Appendix E-2
Comment Letters

3. **SAND HILL WIND, CONDITIONAL USE PERMIT, PLN2017-00201 - HEARING TO RECEIVE PUBLIC COMMENT ON THE DRAFT SUBSEQUENT ENVIRONMENTAL IMPACT REPORT (DSEIR)** - Application to allow repowering of an estimated 671 existing or previously existing wind energy turbine sites with up to 40 new turbines with a maximum production capacity of 144.5 megawatts (MW), using turbines rated between 2.3 and 3.8 MW (potentially up to 4.0 MW) per turbine, on fifteen (15) nearly contiguous parcels on approximately 2,600 acres in the eastern portion of the Altamont Pass Wind Resource Area, bordering both sides of Altamont Pass Road west of Grant Line Road, both sides of Mountain House Road north of Grant Line Road, generally west of Bethany Reservoir and southeast of the intersection of Christensen and Bruns Roads, bearing Assessor’s Parcel Numbers (APNs): 99B 7750-6; 99B-6325-1-4; 99B-6325-1-3; 99B-7375-1-7; 99B-7400-1-5; 99B 7300-1-5; 99B-7050-4-6; 99B-7050-1-9; 99B-7050-4-1; 99B-7350-2-1; 99B 7350-2-15; 99B-7350-2-5; 99B-7500-3-2; 99B-7500-3-1; and 99B-7600-1-1. Subject to certification at a future meeting of the Final Subsequent Environmental Impact Report, tiered under

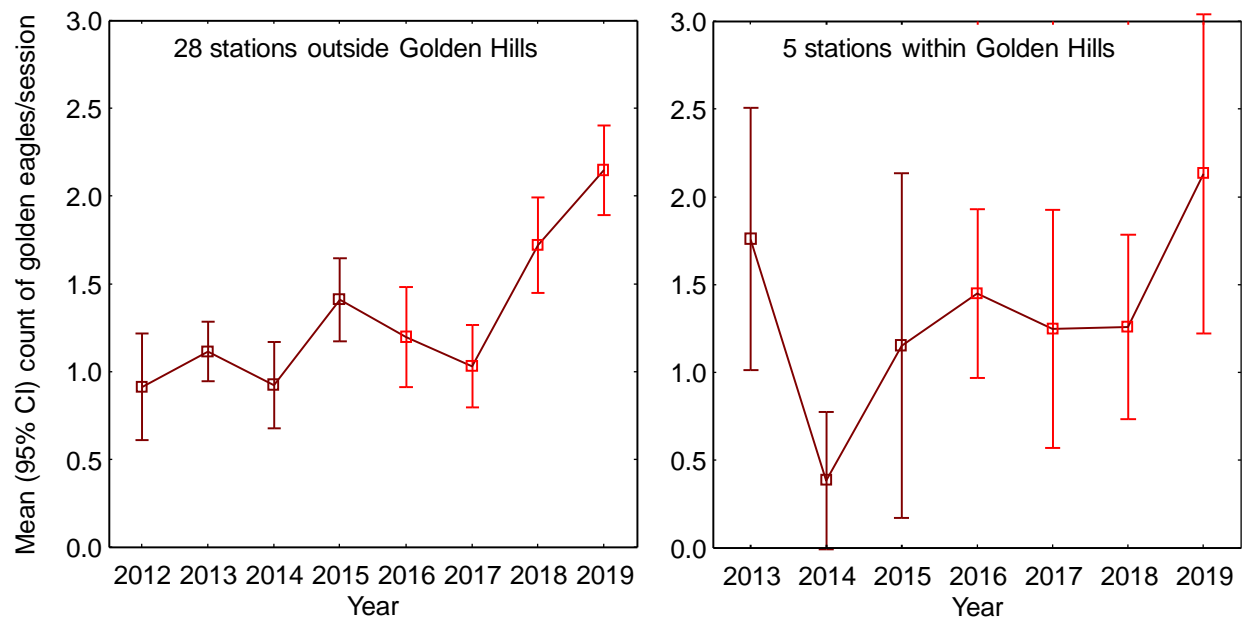
Relative abundance of golden eagles increased over the last two years outside Golden Hills, and over the last year within Golden Hills (Figure 1), but an opportune before-after, control-impact (BACI) comparison reveals no effect on golden eagle abundance caused by the repowering project (Figure 2). Without comparing fatality rates in an experimental design, such as the BACI design that was available for the Vasco Winds repowering project (Brown et al. 2016), it cannot be known whether the collision hazard models were truly effective at Golden Hills. Unlike the case of Vasco Winds, fatality rates at Golden Hills cannot be compared to fatality rates estimated from concurrent monitoring at other wind projects in the APWRA because no such monitoring existed until last year at Golden Hills North. The only means to assess micro-siting is to compare (1) post-repowering fatalities to pre-repowering fatalities at the same wind turbines that were replaced by the new project, and (2) the pattern of fatalities among wind turbines I assessed for collision hazard prior to construction.

Figure 3. Golden eagle fatalities per turbine relative to Combined Hazard Class at Golden Hills (left) and all repowered projects with modern turbines except for Golden Hills North (right), which has not yet reported fatality monitoring results.

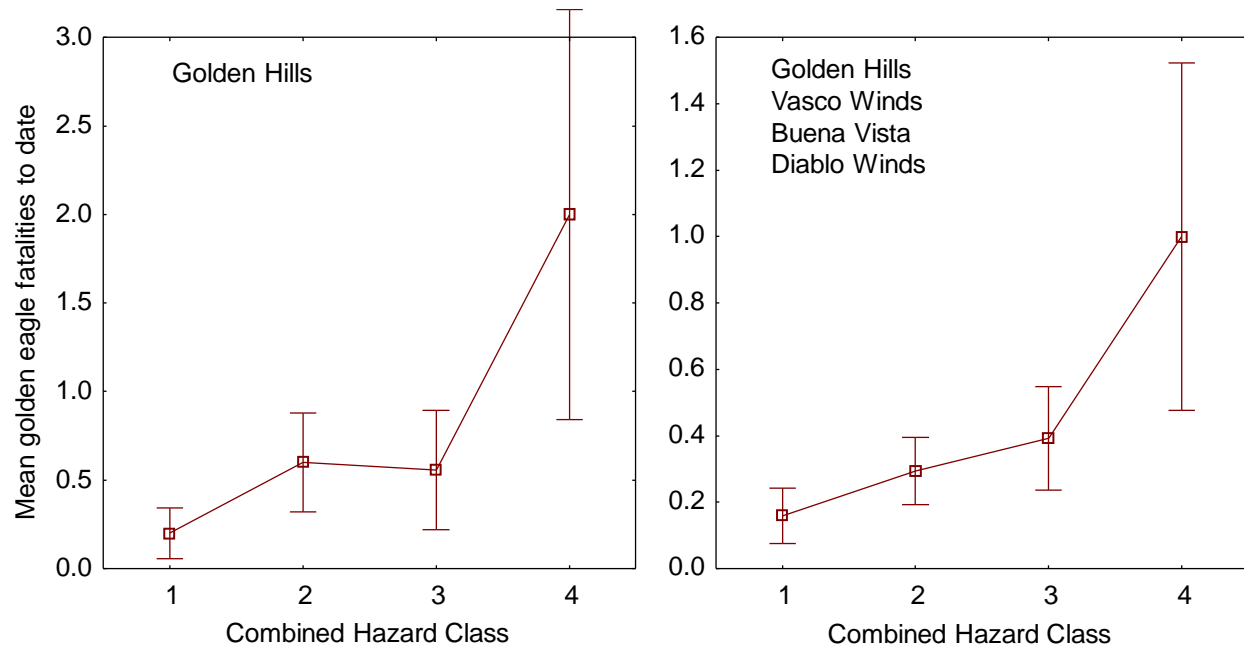
I related the number of golden eagles per turbine to Combined Hazard Class at Golden Hills and to all but one of the repowered projects in the APWRA (Figure 3). Golden eagle fatalities/turbine increased with Combined Hazard Class, and the fatality rate in

Class 4 was 10 times that of Class 1 at Golden Hills. In Class 4, I know of 8 golden eagles to have been killed at only 4 turbines, including 4 at only one of these turbines where I warned a turbine would pose substantial collision risk to golden eagles. At all of the repowered projects except Golden Hills North, golden eagle fatalities/turbine numbered 5 times higher in Class 4 than in Class 1. I am disappointed with the performance of Class 3 at Golden Hills (thus far), but Class 4 demonstrates that the micro-siting recommendations were sound.
